Building Consent: BCN/2017/201380 Byron Street, Sydenham

Addition to Factory – New Offices, Meeting and Store Room

RFI Items

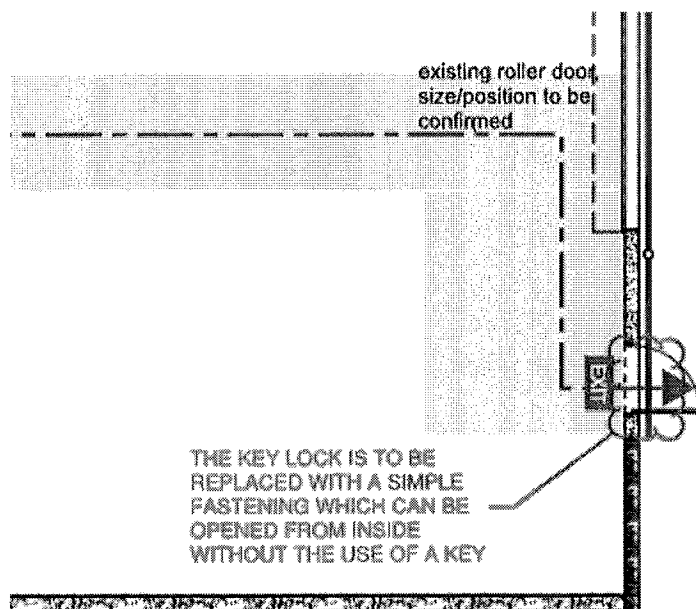
FIR031 – Please provide a door schedule to show the below door lock to be changed.
